# Access Compliance Report

### (Curb Ramps)

Intersection ID: 14977	Main Street: BUCHANAN_ST	Cross Street: KENILWORTH_AV	Location: N
ADA ID: 075E1D4B078A	Ramp Type: Perp	Initial Pass/Fail: Fail	Overall Compliance: No
Severity Score: 26.25			
Codes/Mitigation Info/Possible Solution		Field Measurements/Component Compliance

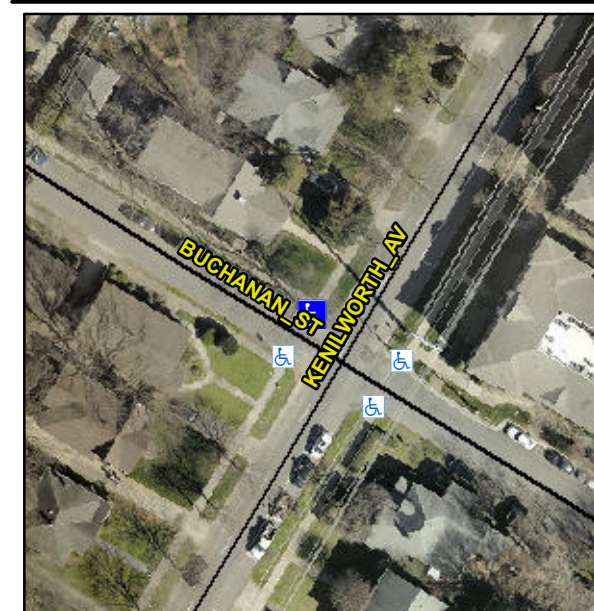
**Not Found, R304.2.2, R304.5.3**

Compliance	Description	Data	Compliance	Description	Data
N/A	Ramp Length (in)	30.0	No	Ramp Slope (%)	13.2
Yes	Ramp Width (in)	60.0	No	Ramp XSlope (%)	3.9
N/A	Flare Type LT	N/A	N/A	Flare Type RT	N/A
N/A	Flare Slope LT (%)	N/A	N/A	Flare Slope RT (%)	N/A
N/A	Flare Traversable LT?	N/A	N/A	Flare Traversable RT?	N/A
N/A	Landing Length (in)	N/A	N/A	DWS Provided?	N/A
N/A	Landing Width (in)	N/A	N/A	DWS Contrast?	N/A
N/A	Landing Slope (%)	N/A	N/A	DWS Length (in)	N/A
N/A	Landing X Slope (%)	N/A	N/A	DWS Full Width?	N/A
N/A	Landing Curb? (Y/N)	N/A	N/A	DWS Offset (in)	N/A
N/A	Shared Landing?	N/A			
N/A	Gutter Ponding?	N/A	N/A	Gutter Slope (%)	N/A
N/A	Gutter Lip Ht (in)	N/A	N/A	Gutter X Slope (%)	N/A
N/A	Painted X Walk1?	No	N/A	Painted X Walk2?	N/A
	X Walk 1 Direction	To SW		X Walk 2 Direction	N/A
N/A	X Walk 1 Width (in)	N/A	N/A	X Walk 2 Width (in)	N/A
	X Walk 1 Slope (%)	3.0		X Walk 2 Slope (%)	N/A
	X Walk 1 X Slope (%)	1.4		X Walk 2 X Slope (%)	N/A

**Remove & Replace Entire Ramp.**
